This is to certify that CITY OF PORTLAND/Tumer Construction Company/Philip Colem  
has permission to Airport Terminal- 3-Story Steel frame terminal w/ selective demolition connecting to existing terminal & Parking  
AT 947 Westbrook St CBL 199 A001002

Subject: Application ID: 2008-0137

Proposed Project Description:  
Airport Terminal- 3 Story Steel frame terminal w/ selective demolition connecting to existing terminal & Parking Garage

1. Portland Fire Department comments
2. Site plan
3. View of terminal addition from west
4. Level 2 plan (ticketing hall and baggage make-up room)
5. Level 3 plan (departures lounges and concessions)
6. Level 4 plan (passenger security screening)
7. Interior view of atriums 1 and 2

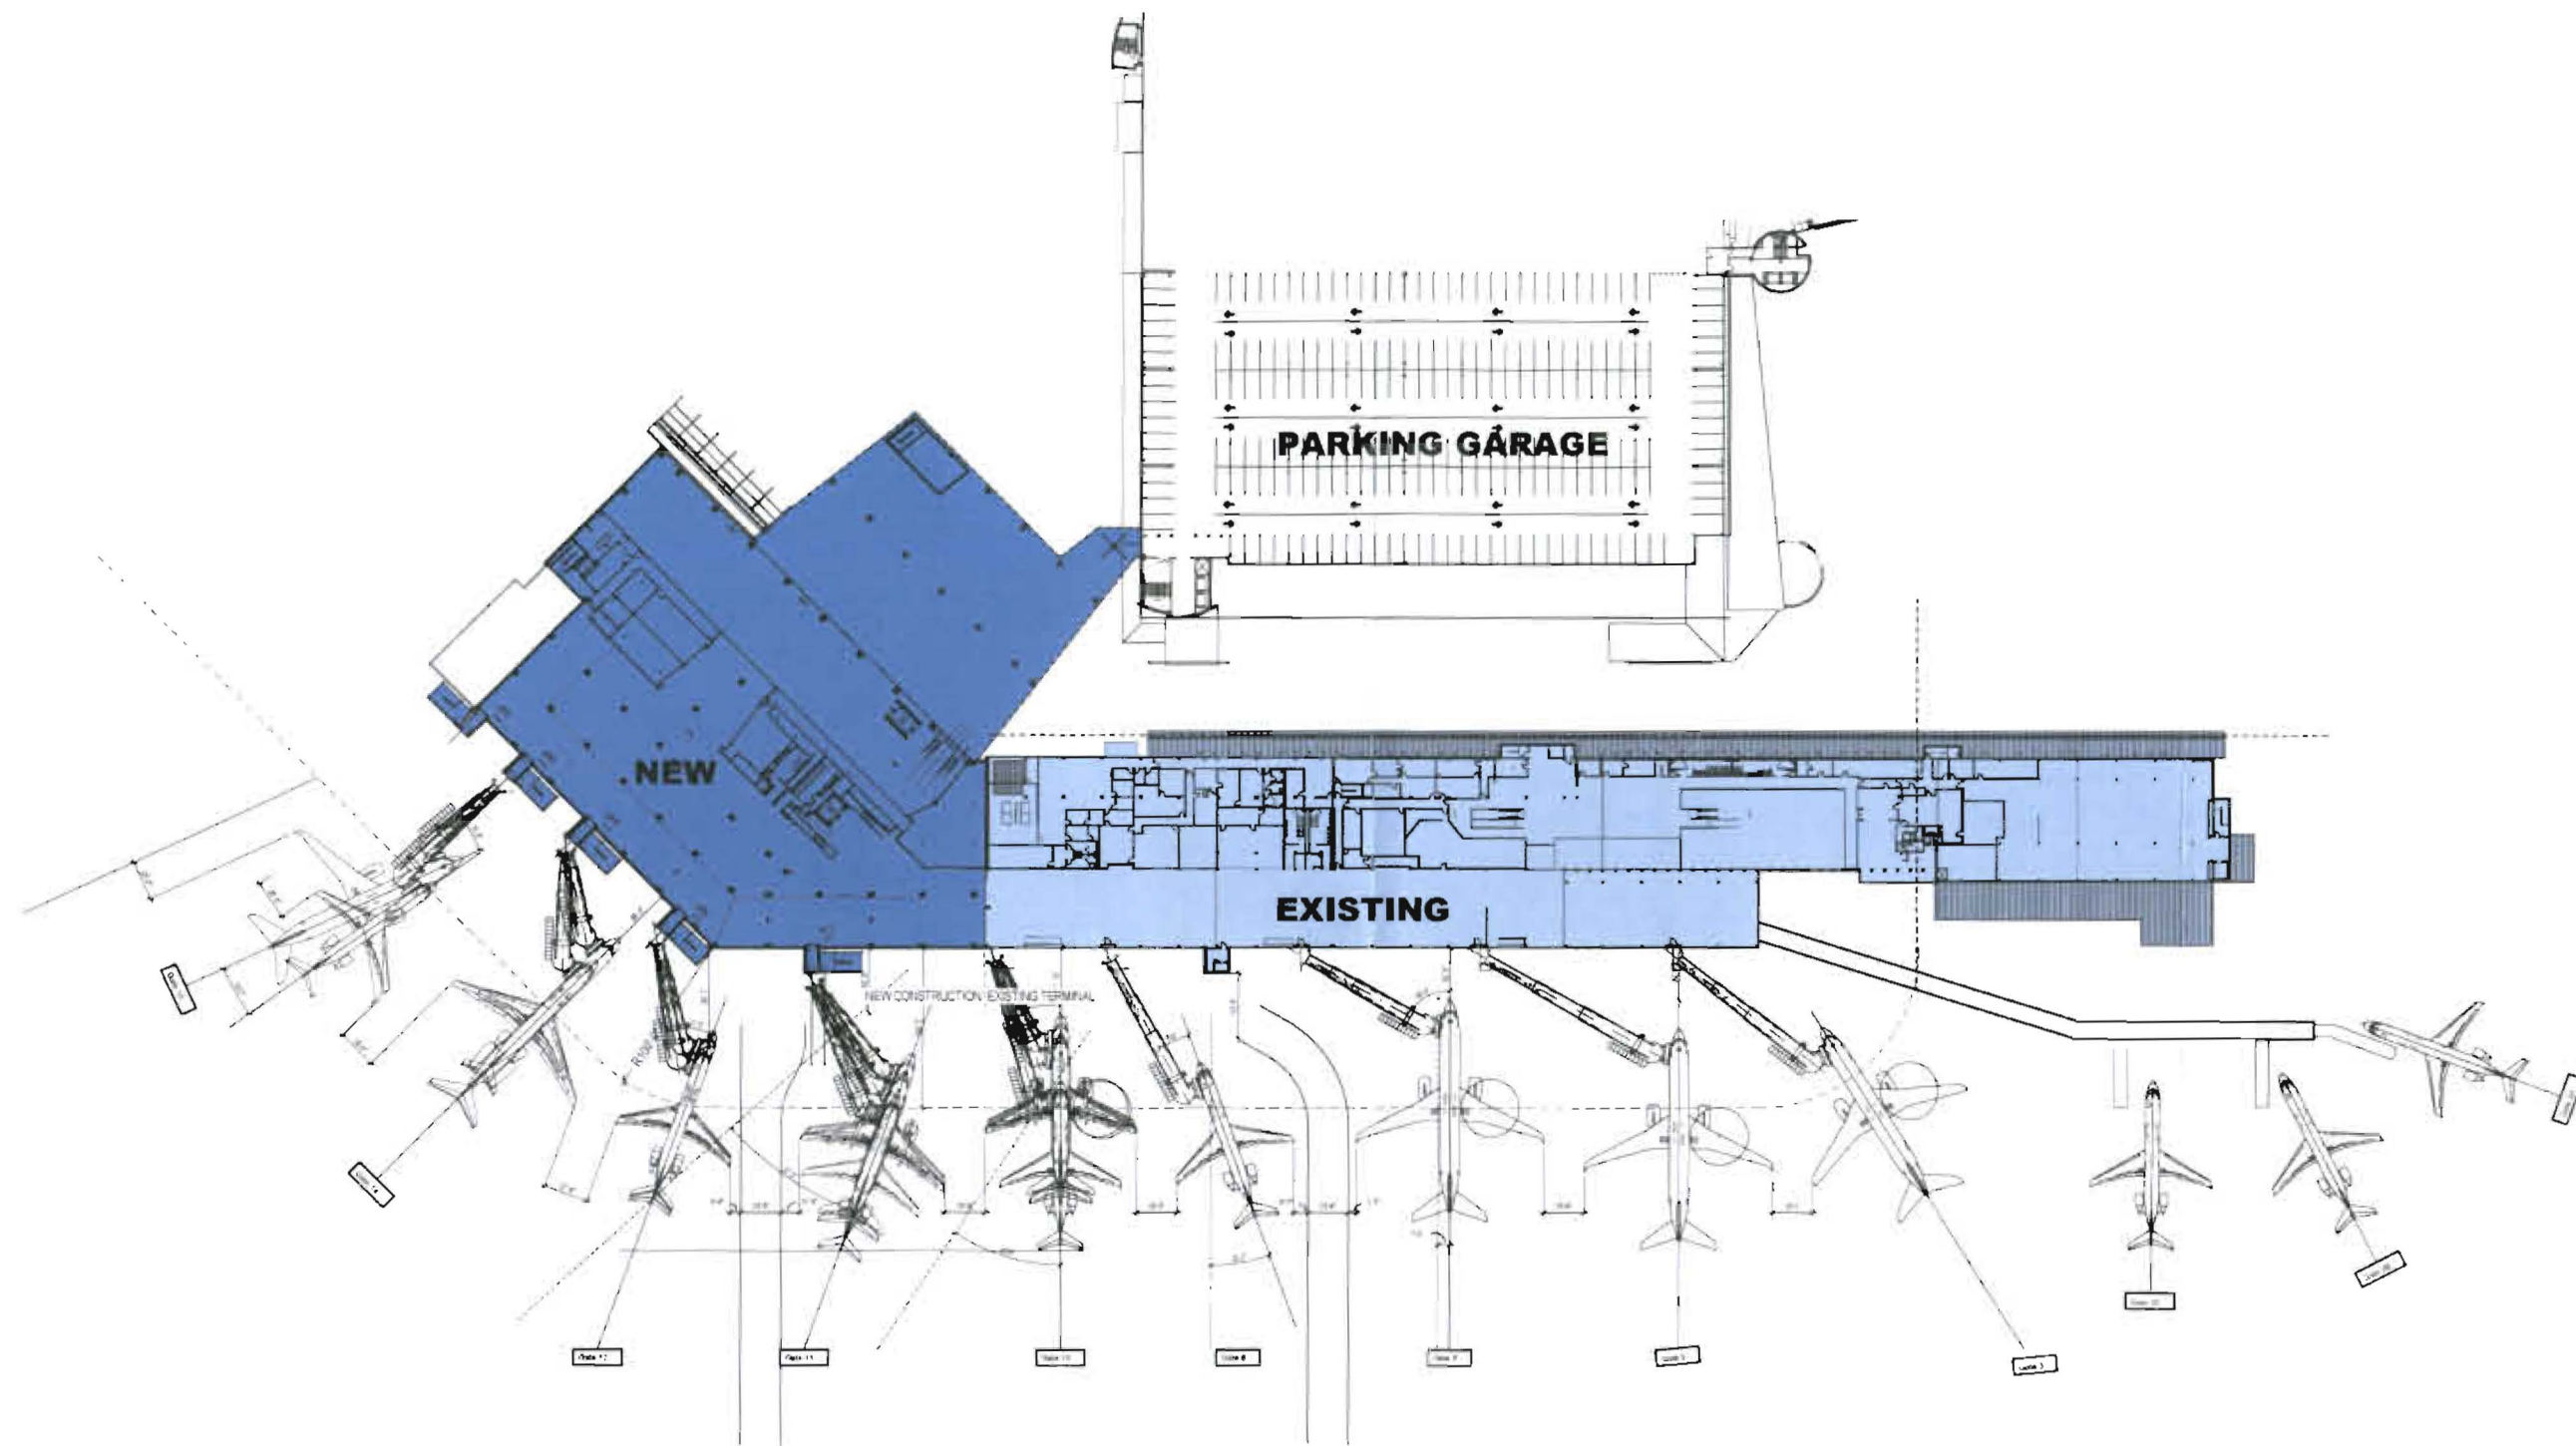
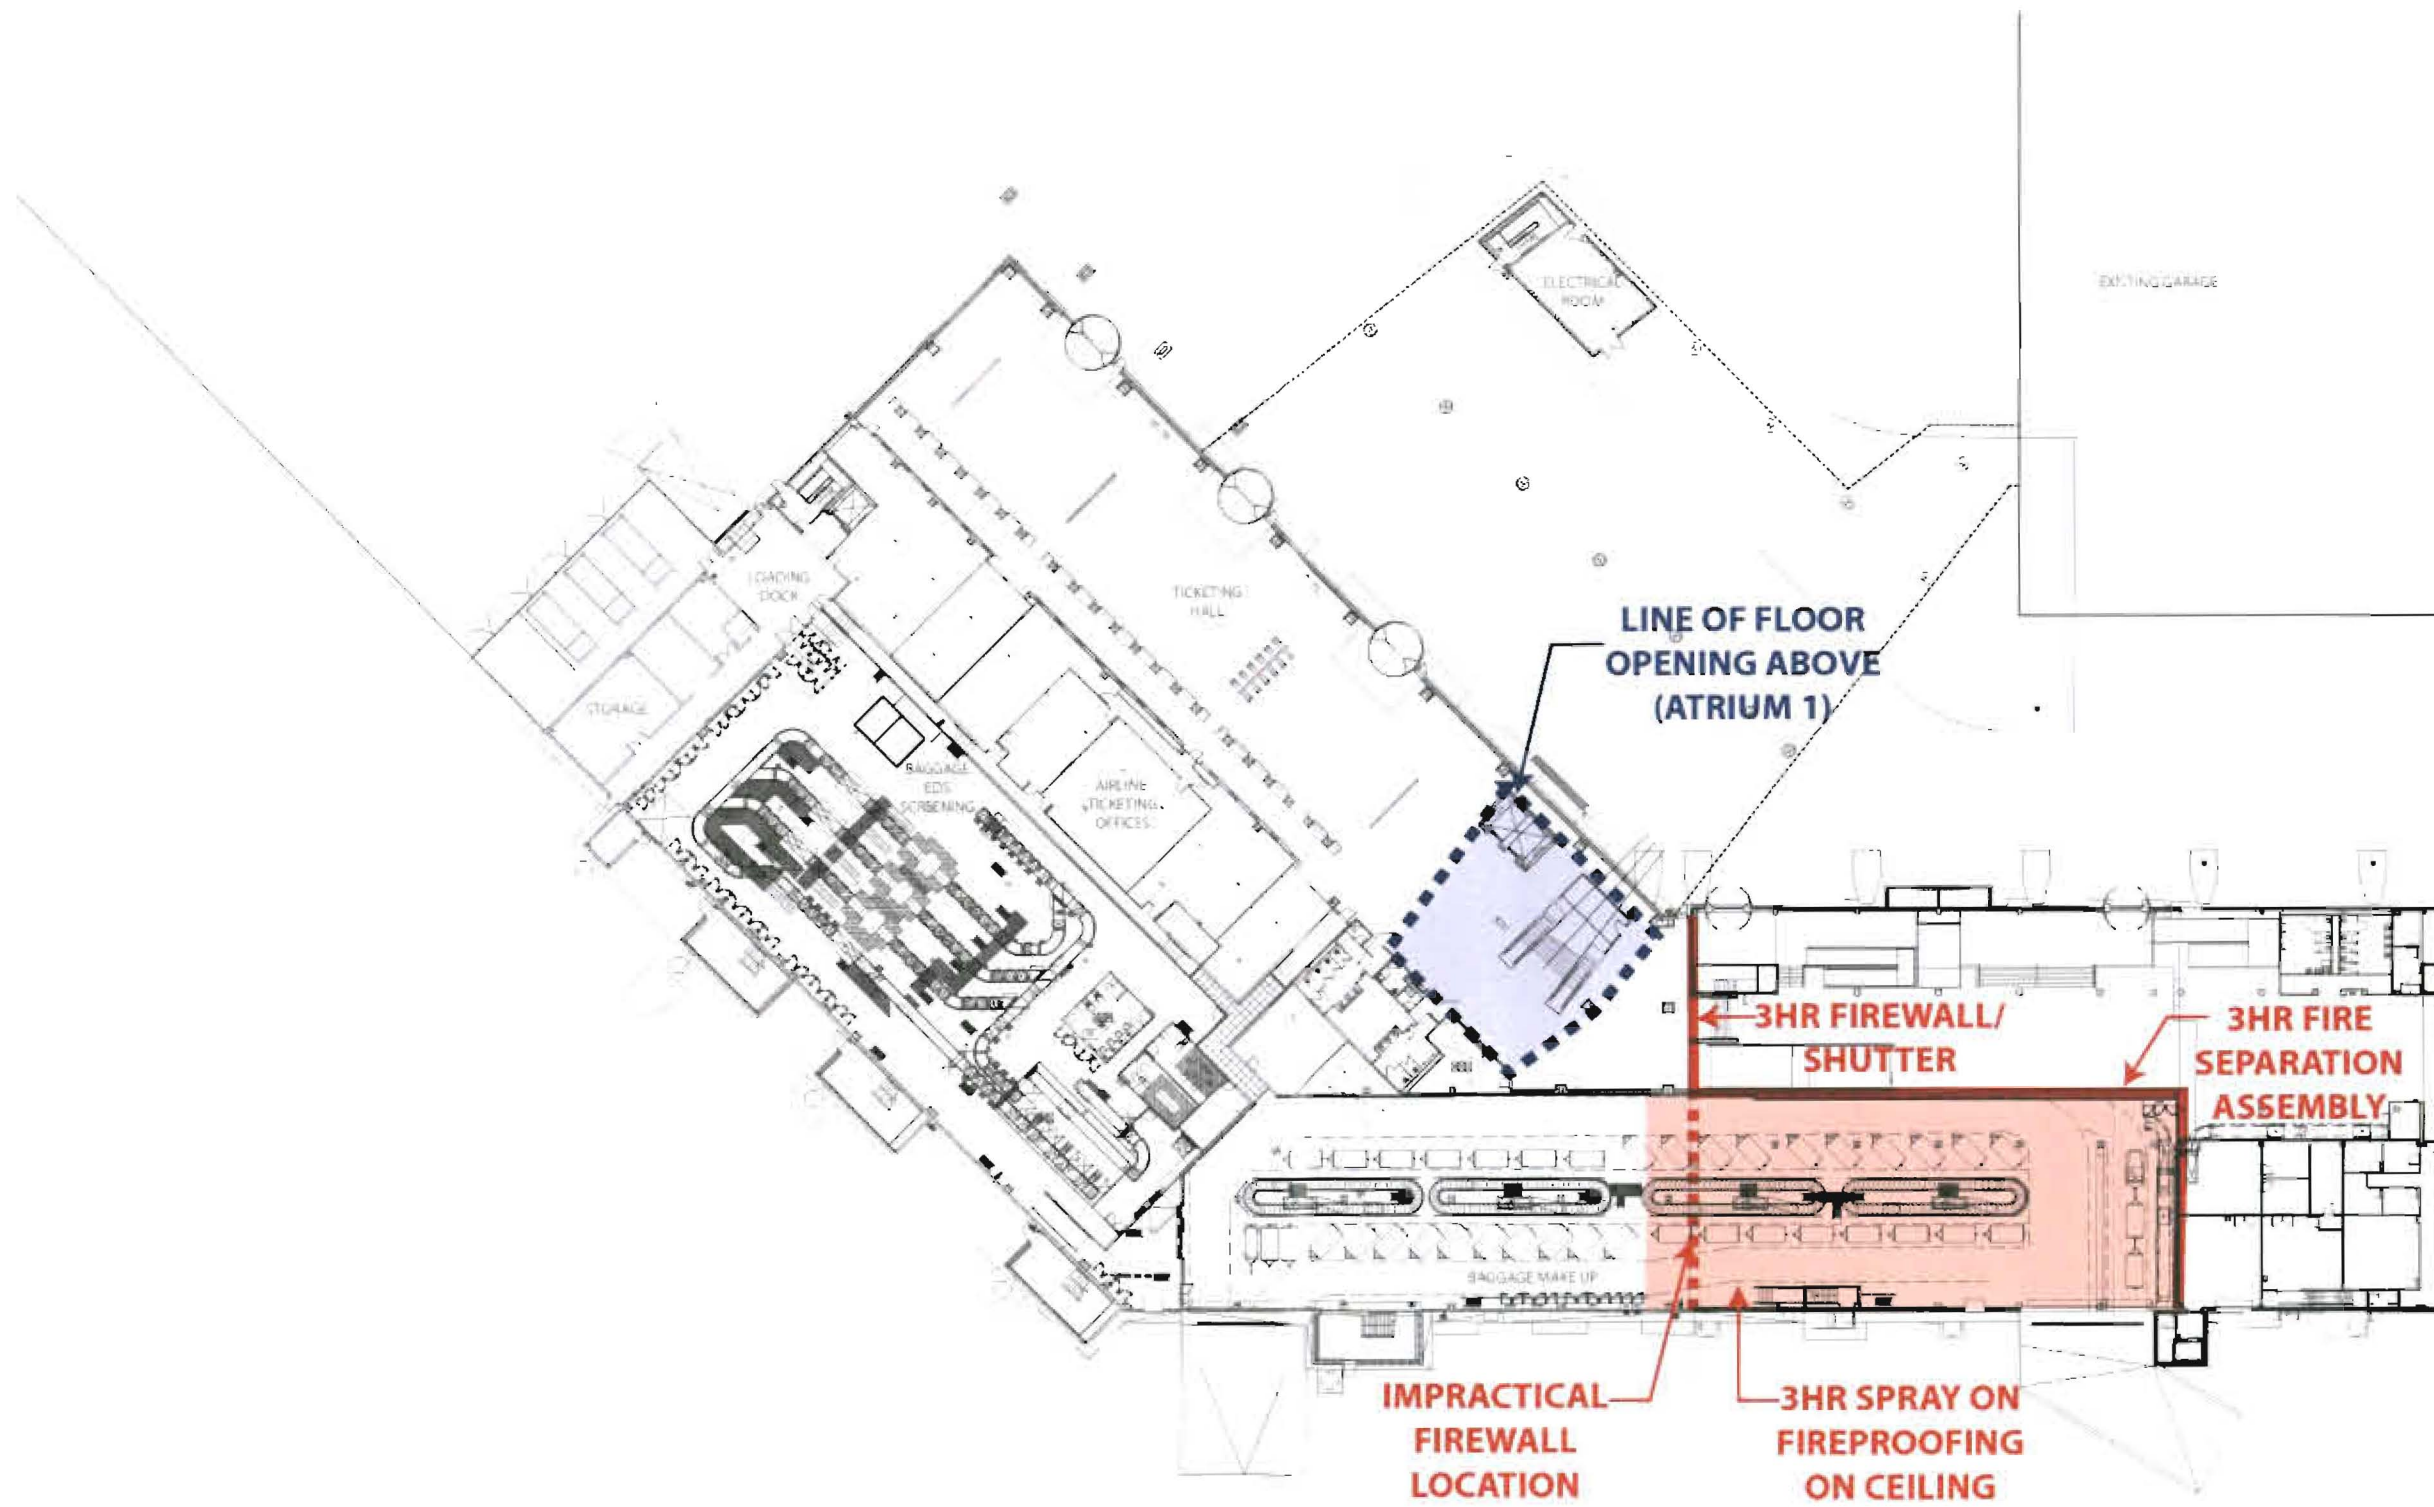
We are requesting approval to reference the IBC 2009 edition for the smoke control exception only. Considering that codes are continually updated to reflect improved testing, building sciences research and real-world building performance, we believe that this does not compromise life safety. Additionally, when the terminal addition is complete in 2012, the IBC 2009 edition may be the applicable code, if adopted by the City of Portland as currently planned. Floor plans and views of the two atriums are included as attachments 4 through 7.
